# Access Compliance Report

## Public Rights-of-Way

### (Curb Ramps)

Intersection ID: 30453	Main Street: HAWKEYE_DR	Cross Street: WALLAND_LN	Location: NE
ADA ID: 3EA7A6D4EBFD	Ramp Type: BlendTrans2	Initial Pass/Fail: Pass	Overall Compliance: No
Codes/Mitigation Info/Possible Solution		Field Measurements/Component Compliance	
Severity Score: 15.25

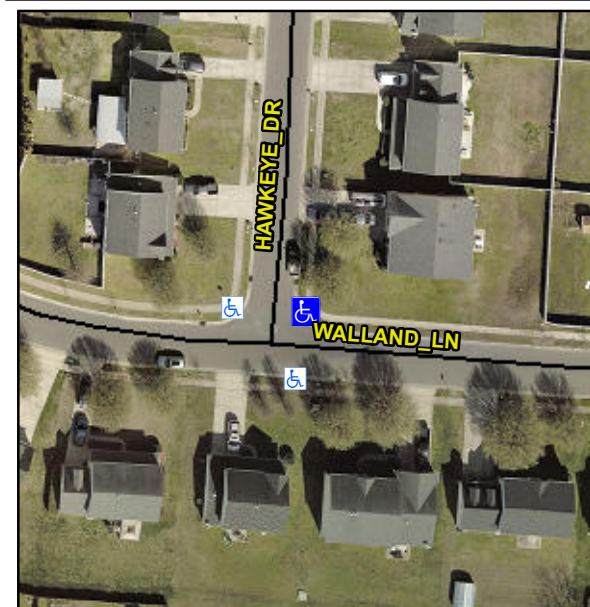
**Remove & Replace Curb Ramp With Two New Directional Ramps or Equivalent. Remove & Replace Gutter.**

**Not Found, R304.5.3, R305, R304.5.4**
